Pre-Filed Testimony of William A. Rozeboom

**Submitted on behalf of Appellant
Airport Communities Coalition**

PCHB No. 01-160
ACC & CASE v. Dept. of Ecology & Port of Seattle

Subject: Comments on stormwater management plan for proposed 3rd runway development actions at Seattle-Tacoma International Airport.

Figure 4

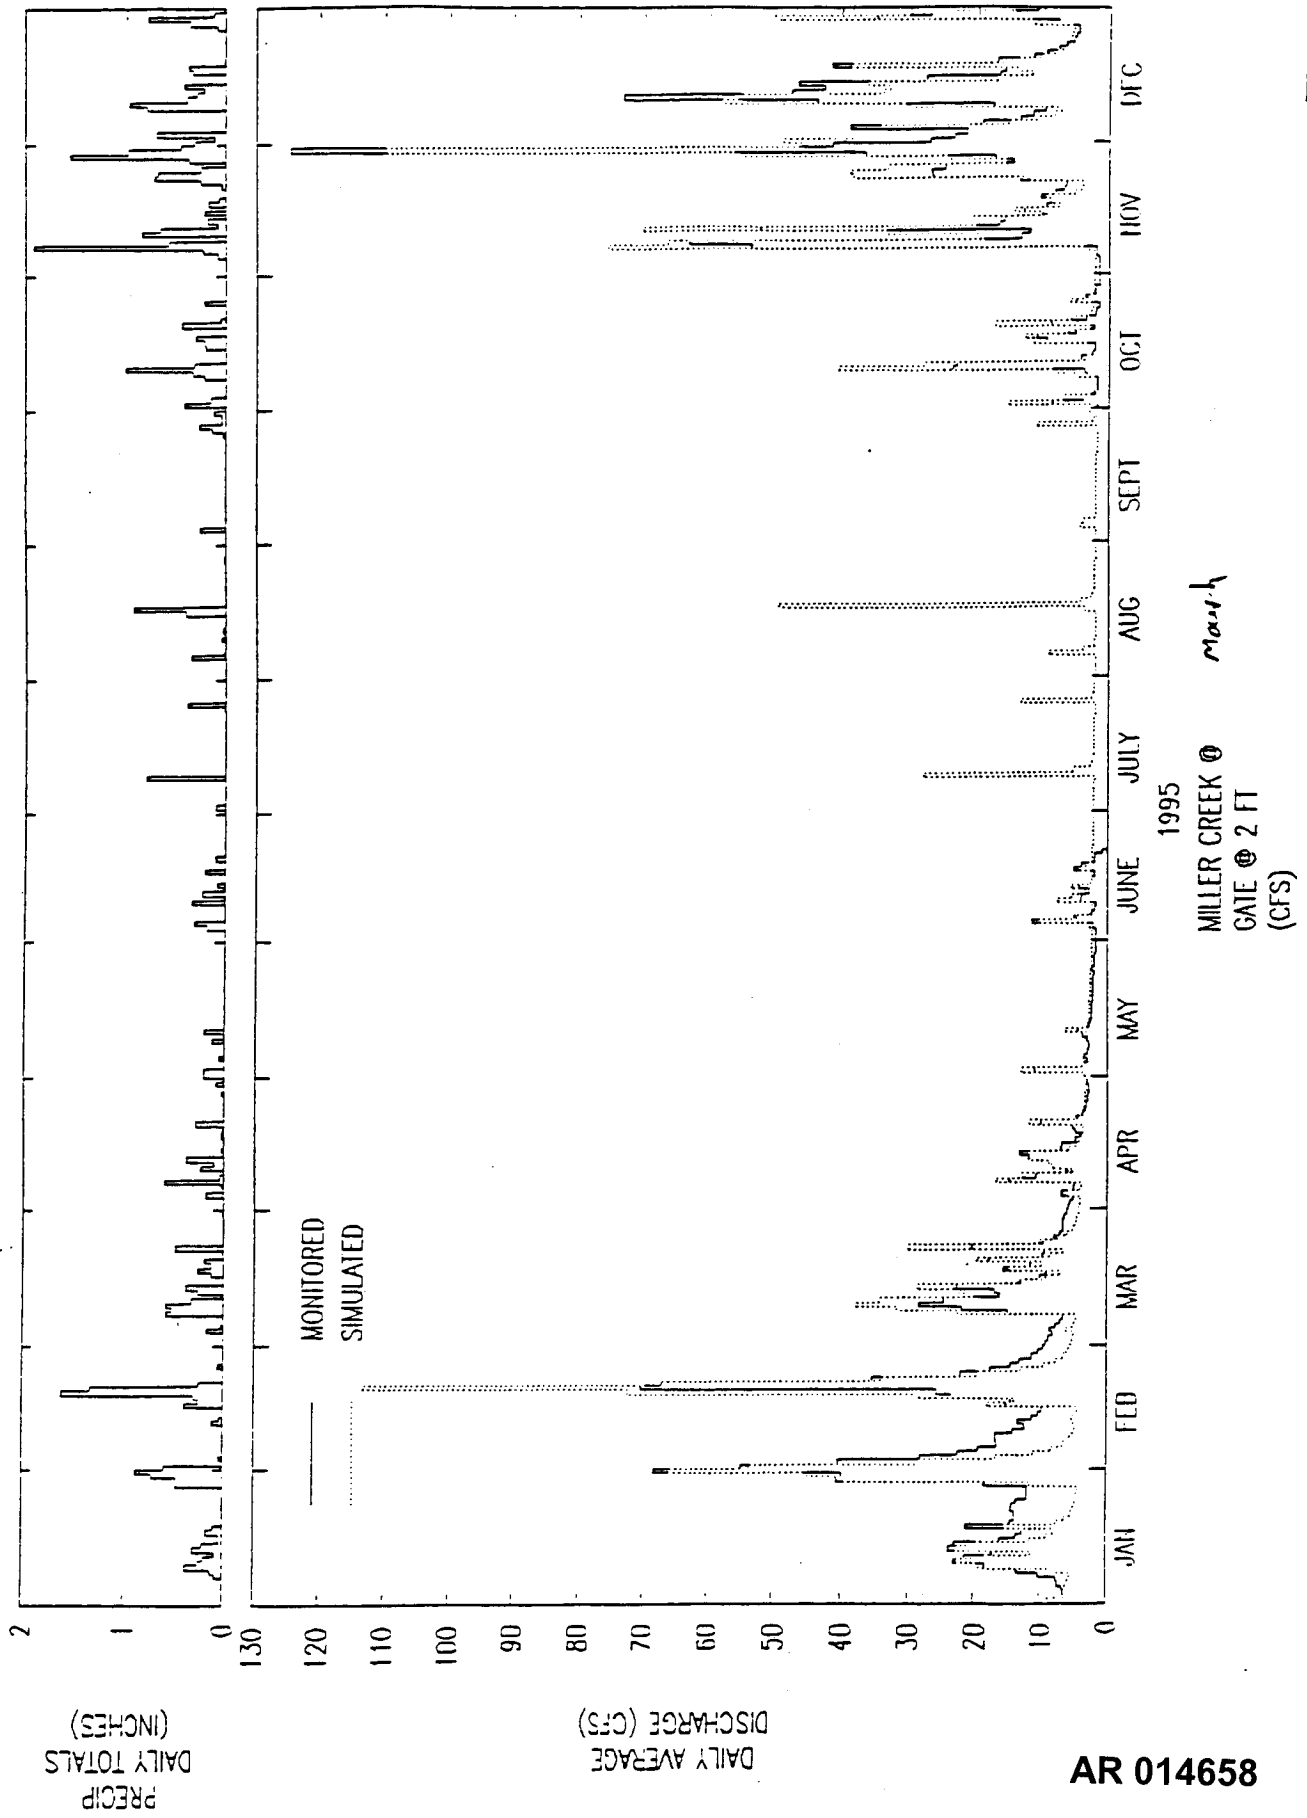
16. The SMP does not provide any information to describe the results of calibration of the Miller Creek HSPF model. SMP page 3-11 states that the HSPF model for Miller Creek was calibrated at two locations and implies that runoff data from several major runoff events in late 1995 and early 1996 were used as the basis for calibration. (This and other text implies that the current model is different from the 1995 Montgomery Water Group model which was based on calibration to events in 1990 and 1991.) The SMP does not provide any text or discussion on how the model was calibrated or the success of the model in reproducing recorded streamflows. SMP page 3-11 states only that "Plots of the HSPF calibration for Miller and Des Moines creeks. . . are shown in Figure B-3." However, calibration plots for Miller Creek were not provided in our copy of Figure B-3 or elsewhere in our copy of the SMP document or its appendices. Without this information, we have no way of assessing whether the HSPF-determined target flows for existing conditions are reasonable or if they are too high and would worsen problems of channel erosion. We suspect that problems with model calibration of the Miller Creek model may be responsible for the highly-questionable SMP target flows identified in comment 14 above.

As noted in the FEIS, emphasis was placed on calibrating the model to accurately simulate the peak flow events in the record in order to accurately estimate the peak flood flow frequency curve. Figures 4 and 5 included in this response show a comparison between the monitored and simulated results at the MCDF and the mouth of Miller Creek for 1995 through August 1996. These figures show the close correlation between the recorded values and simulated flow frequencies.

**Figure 1.3-1
Master Plan Update
Improvement Projects
at STIA**

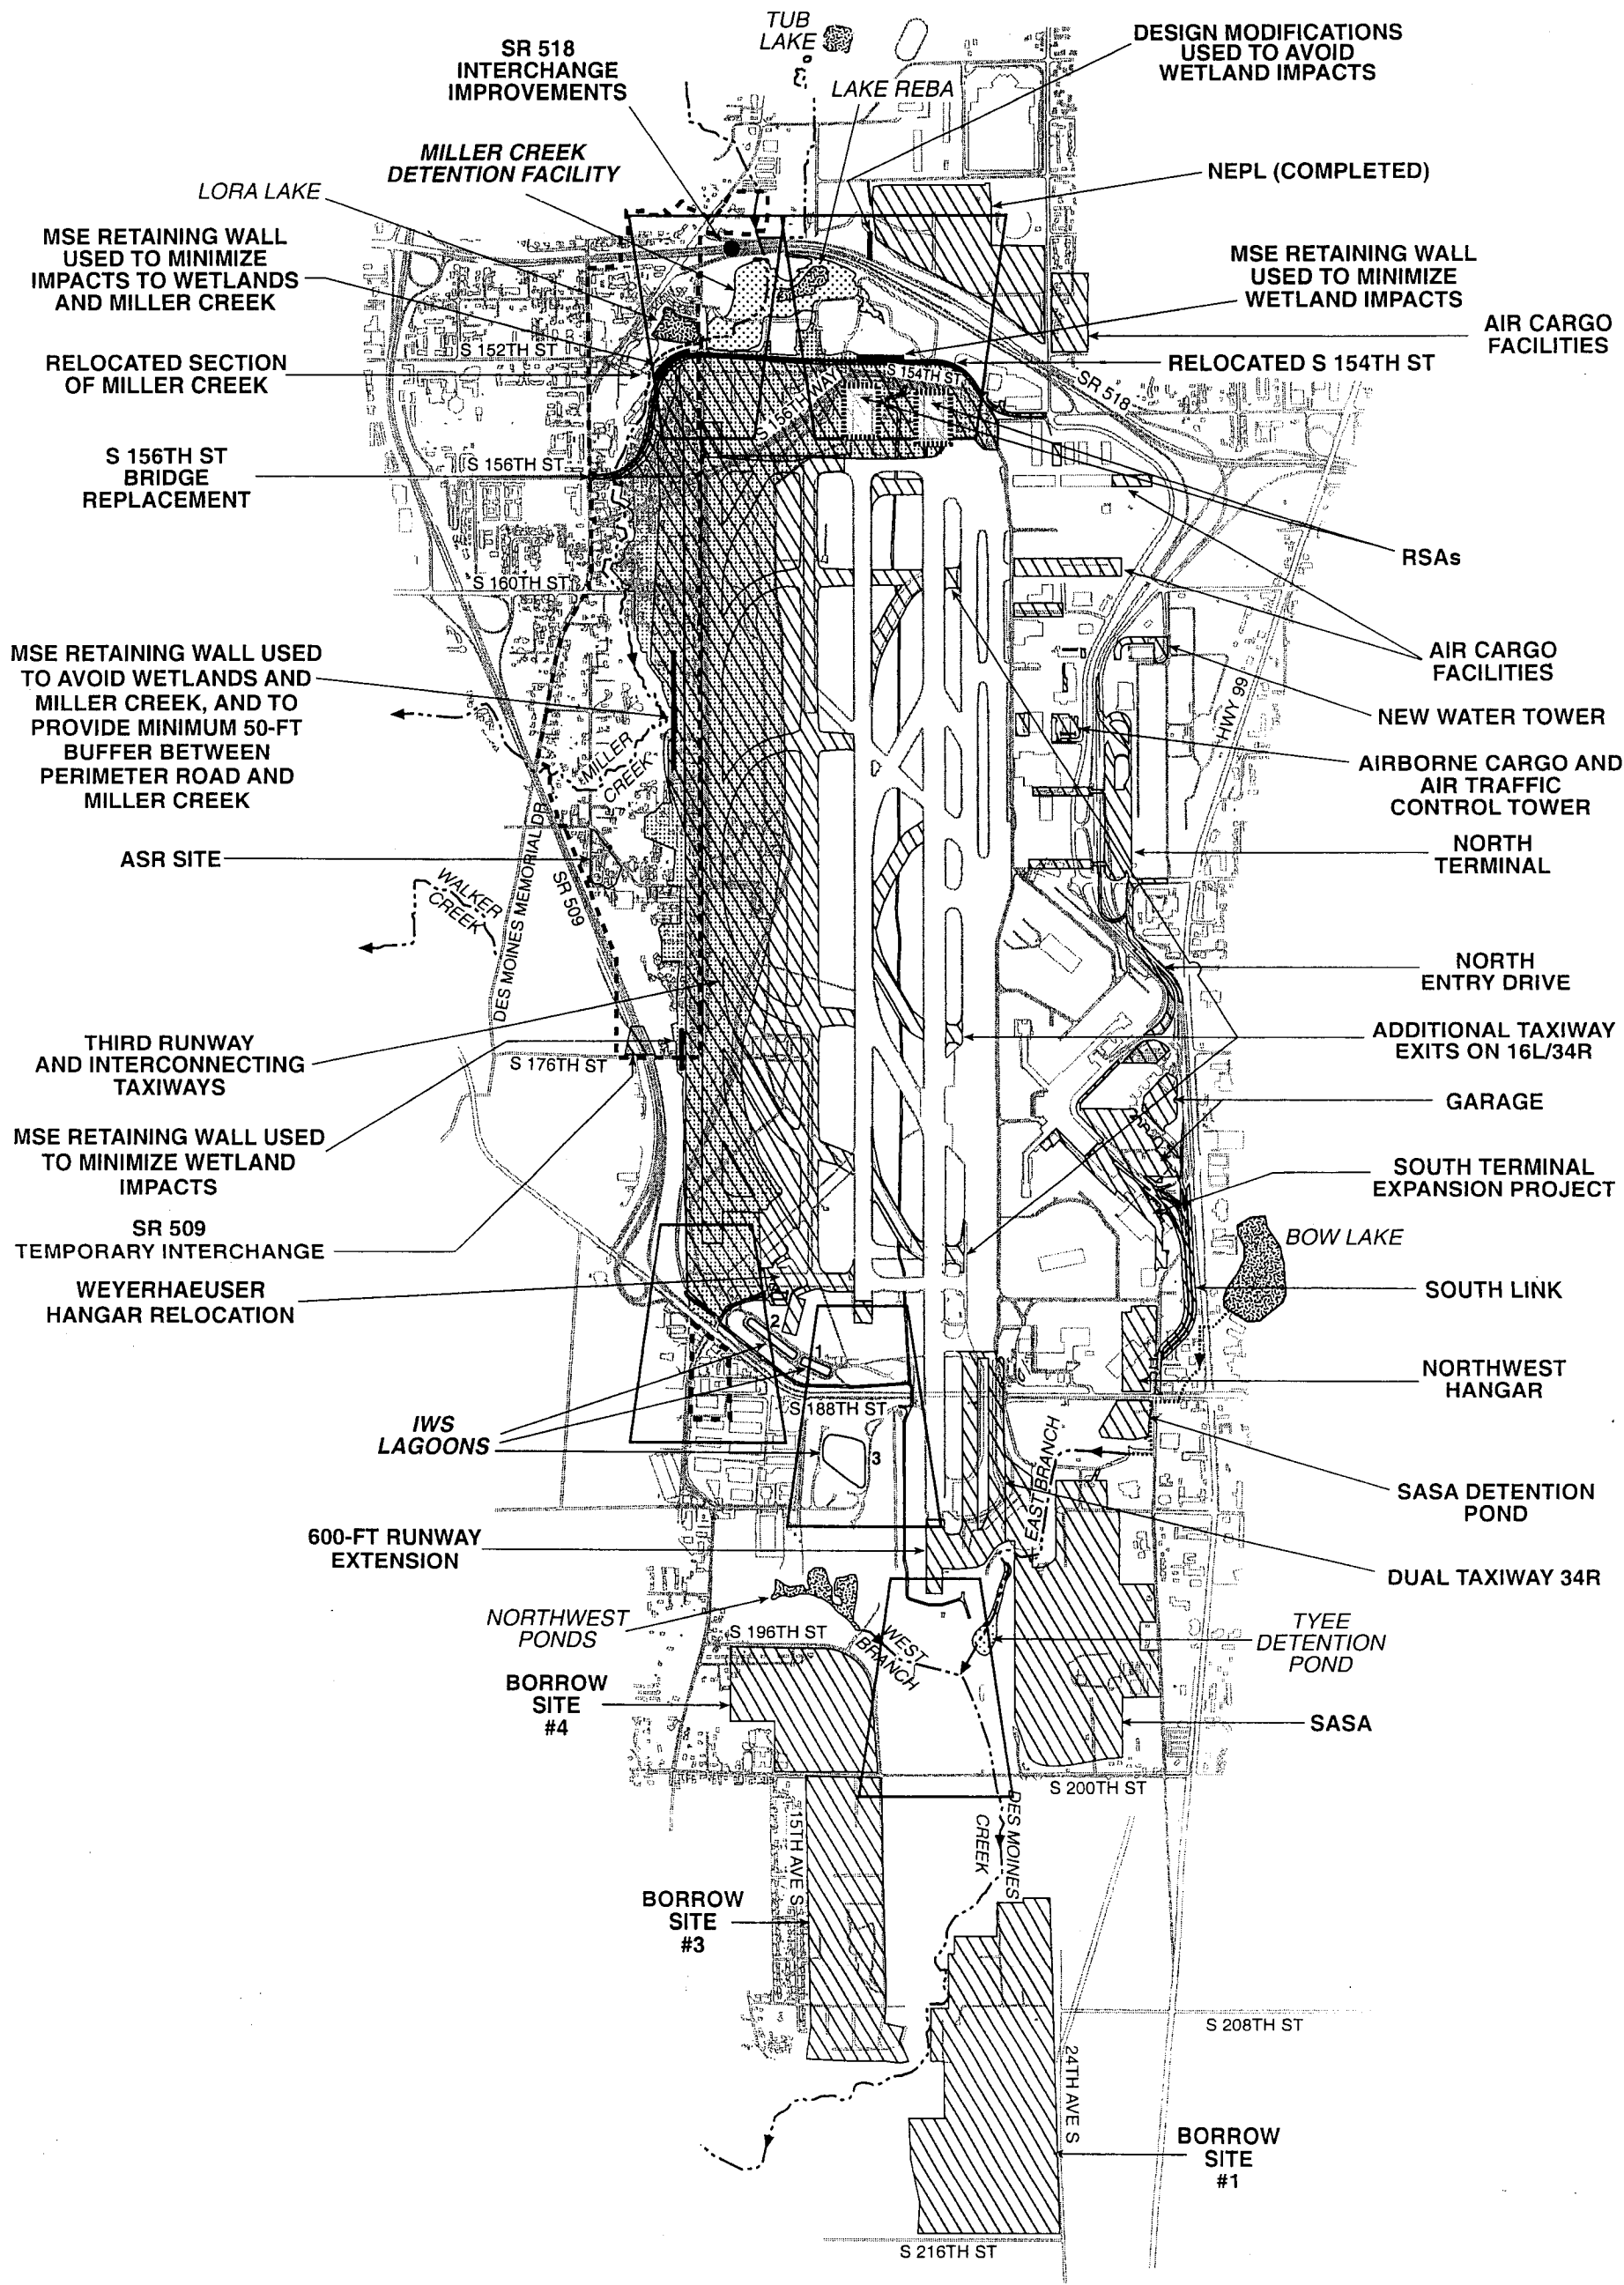
21. The location and large size of the borrow pit sites relative to other airport features is shown by NRMP Figure 1.3-1, attached as **Exhibit M**. When we previously raised the issue of borrow pit impacts in our (Exhibit D) comments, the Port's April 30, 2001 response (Exhibit E) was that "*The potential hydrologic impacts of the borrow areas were not evaluated in the Comprehensive Stormwater Management Plan because the Port believes that modifications are considered temporary and reversible, as opposed to the construction of permanent new*

- The November 2001 NRMP (Figure 1.3-1 and elsewhere) shows that Borrow Areas 1, 3, and 4 are Master Plan Update Improvement Projects. If the agreement described in the Port's October 2001 memorandum is (was) executed and the Port in good faith pursues and accomplishes site redevelopment as described, then Borrow Areas 3 and 4 will be fully redeveloped as aviation commercial and operation properties as of year 2006. That is the same year adopted in the SMP to represent future conditions for the other Master Plan Update projects.

- The on-site borrow areas (1, 3, and 4), which are proposed to be mined as a source of about 6.7 million cubic yards of fill material, are shown by NRMP Figures 1.3-1 and 4.1-2 to have a combined excavation and future development footprint of about 155 acres. Borrow Areas 3 and 4 alone have an excavation and development footprint of about 60 acres. NRMP Figure 2.1-1 shows that the combined footprint of the borrow areas is comparable in size to the footprint of the third runway embankment, for which detailed hydrologic impact assessments have been performed.

Low Flow Occurrences in Miller Creek, 1949-1995 (1994 HSPF)

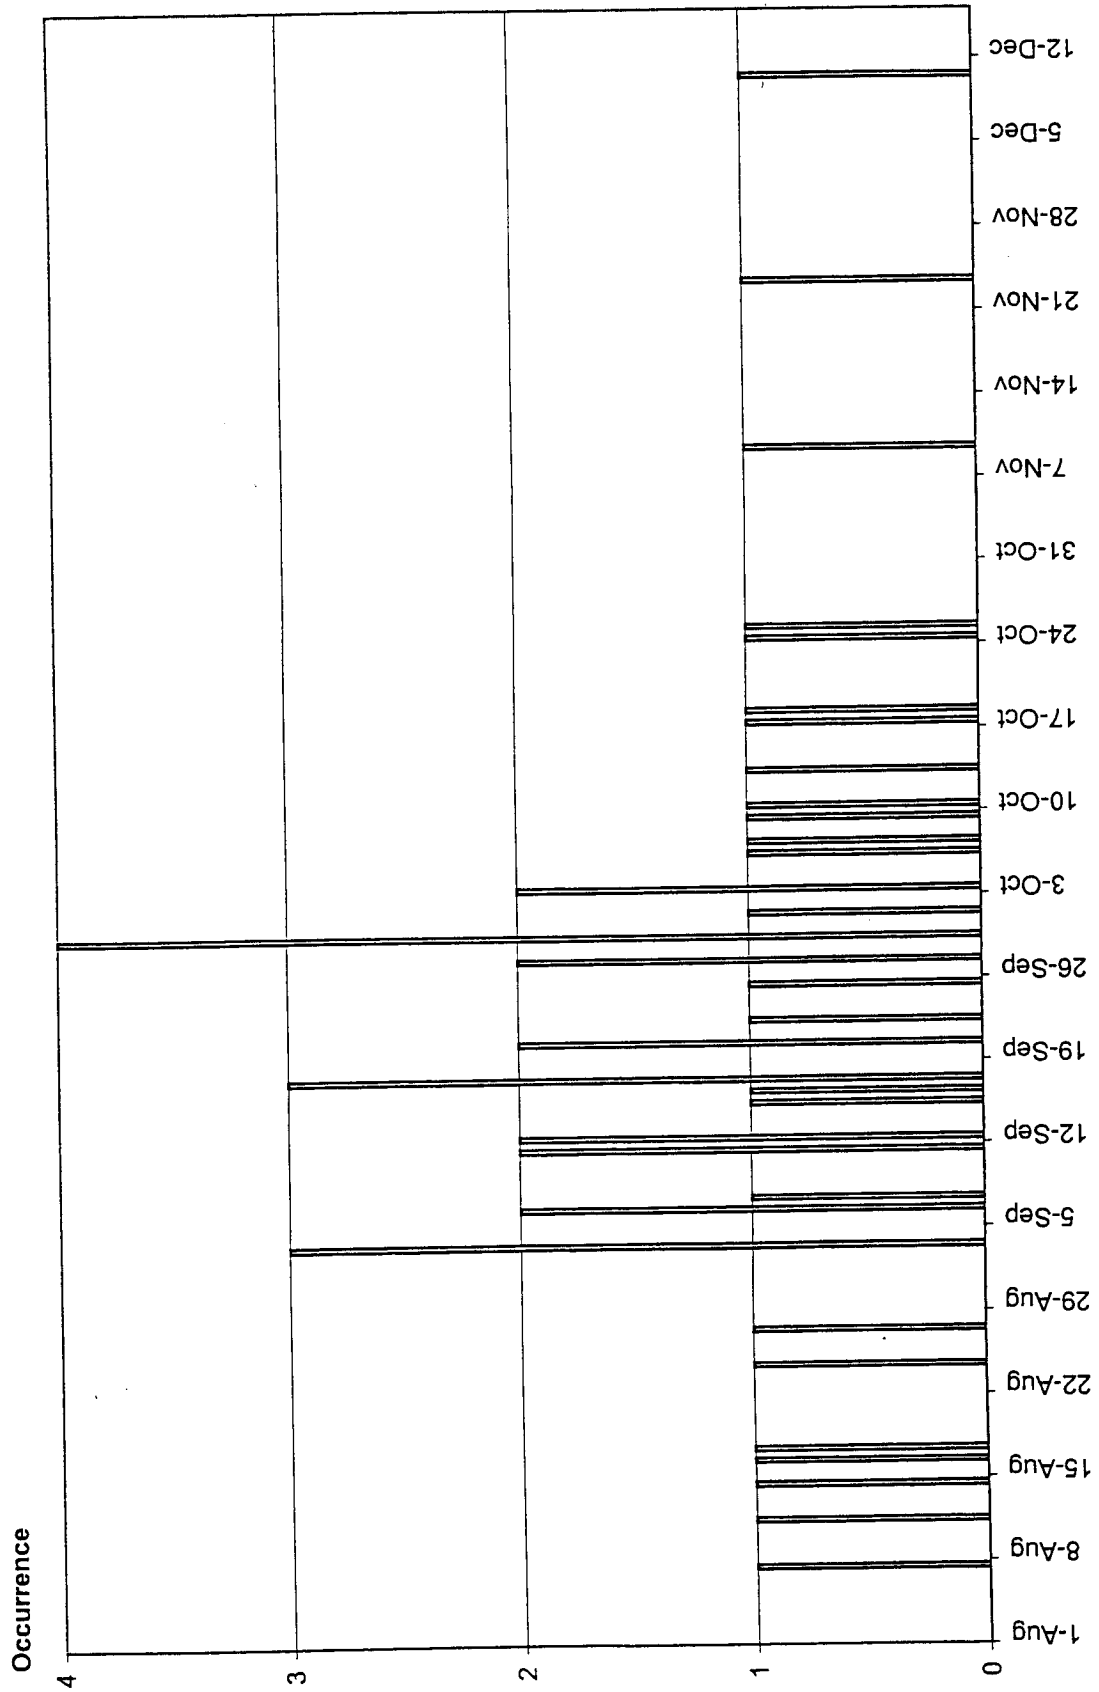
text are inconsistent with the low flow periods shown by the figures in LFP Appendix I, titled “*Determination of Low Flow Quantity Impacts and Mitigation*”. For Des Moines Creek, the historical period with occurrences of annual 7-day low streamflows is shorter than the proposed mitigation period. However, for Walker Creek, the supporting data show that annual low flows occur over a much longer period than the 92 days for which mitigation is proposed. The Port’s LFP chart showing 7-day low flow occurrences in Walker Creek is attached as **Exhibit O**. It shows that annual 7-day low flows over the simulation period have occurred during the 152-day period from June 17 through November 16. Notwithstanding the serious model calibration problems which introduce further uncertainty to the mitigation proposal, the current LFP proposed Walker Creek low flow augmentation only for a 92 day period beginning on August 1, and fails to offer any mitigation for much of the period in which Walker Creek low flows are anticipated to occur based on the Port’s modeling.

streamflow events.” The LFP does not provide any data to substantiate the claim that the 2-year, 7-day low flow is an appropriate target. Regardless, close inspection of the LFP Appendix I data shows that the impact assessments for both Walker and Miller Creeks are actually based on approximately a 7-day, 4-year-frequency impact. The issue does not affect the analysis of Des Moines Creek impacts, which were based on the full 47 years of simulation record. The LFP supporting calculations show that low flow impacts for Miller and Walker Creeks are based on a statistical analysis of years 1991 through 1994, corresponding to “*a representative dry period*” (LFP Page 2-11 paragraph 3) for which embankment seepage modeling was conducted by PGG and integrated with the HSPF model. The statistical analysis of the four data points for years 1991 through 1994 fails to recognize that these dry years are not representative of longer-period conditions. Other tables in LFP Appendix I show that for Walker Creek, for example, these years ranked as the first, fifth, tenth, and 25th driest years in a 47-year period of simulation record. The dryness of these four years is such that a 50% exceedance (2-year return period) low flow value computed from these years is actually more representative of about a 25% exceedance (4-year return period) in the context of the longer 47-year record. A similar conclusion is found in the 4-year versus 47-year record for Miller Creek. Because of the LFP statistical manipulation, it is misleading for the LFP text to state that that low flow impacts for Miller and Walker Creeks are based on a 2-year return period. Furthermore, if the statements made in the LFP to support selection of a 2-year-frequency impact are correct, then the actual use of a 4-year-frequency impact will underestimate impacts for 2-year and more frequently-occurring events.
